SERVICE BULLETIN RIP

SHOCK ABSORBER AND FRONT SHOCK MOUNT

B-035A

The purpose of this bulletin is to announce the release of a **new** shock absorber kit for all 1995-2000 S1, S1W, M2, S2/S2T, S3/S3T, and X1 Model Buell motorcycles and to provide installation and adjustment instructions. Buell Motorcycle Company has developed this kit as an upgrade to the shock absorbers currently in use.

Figure 2. New Shock Absorber Assembly

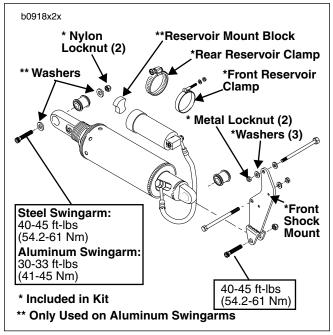
The new front shock mount MUST be used with the new shock absorber. The new shock is 1.77 in. (45 mm) shorter than the previous shocks and requires the new front mount to align and install properly.

- See Figure 2. Install new front shock mount to crankcase with two new front shock mount bolts, washers, star washer (on 1997 M2, S3/S3T models only) and metal locknuts. Tighten bolts to 30-33 ft-lbs (41-45 Nm). NOTE: Top bolt goes in from the left side, bottom bolt goes in from right side. Bottom bolt does not use washer under bolt head. Star washer (only used on 1997 M2, S3/S3T models) goes on bottom bolt under the washer on the nut side. If exhaust was loosened during front shock mount removal, replace exhaust gaskets and reinstall exhaust. See appropriate Service Manual, Section 2 for instructions.
- All Models Except S1/ S1W/S2/S2T: Apply LOCTITE THREADLOCKER 243 (Blue) to threads of new button head fastener. Fasten voltage regulator bracket to front shock mount with new small button head fastener. Tighten fastener to 5-6 ft-lbs (7-8 Nm).
